WIRING OF THE NEUTRAL SAFETY SWITCH ON "93" MODEL YEAR CHASSIS

WIRING OF THE NEUTRAL SAFETY SWITCH ON "94" MODEL YEAR CHASSIS

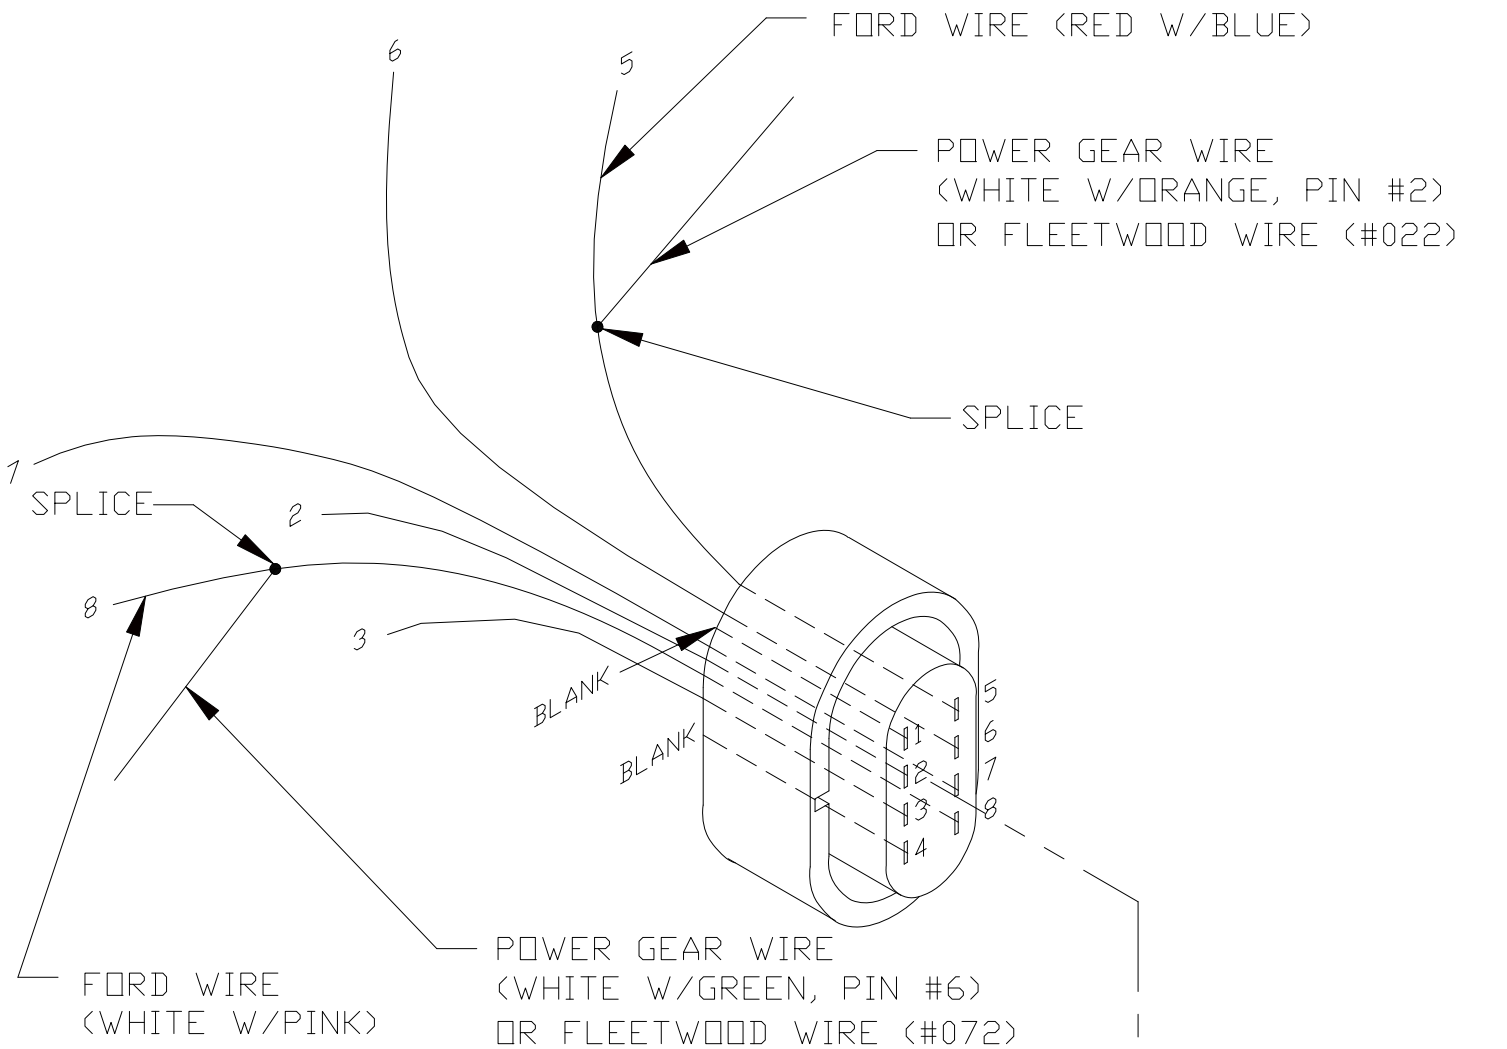
FORD CHANGED IT'S WIRING OF THE 8 PIN PLUG IN '94. THE RED W/BLUE WIRE MOVED FROM PIN 6 TO PIN 5. THE MIL. CYL. WIRE OR FLEETWOOD WIRE (WHICH EVER IS USED) WILL REMAIN SPLICED TO THE RED W/BLUE WHERE EVER IT'S LOCATION MAY BE.
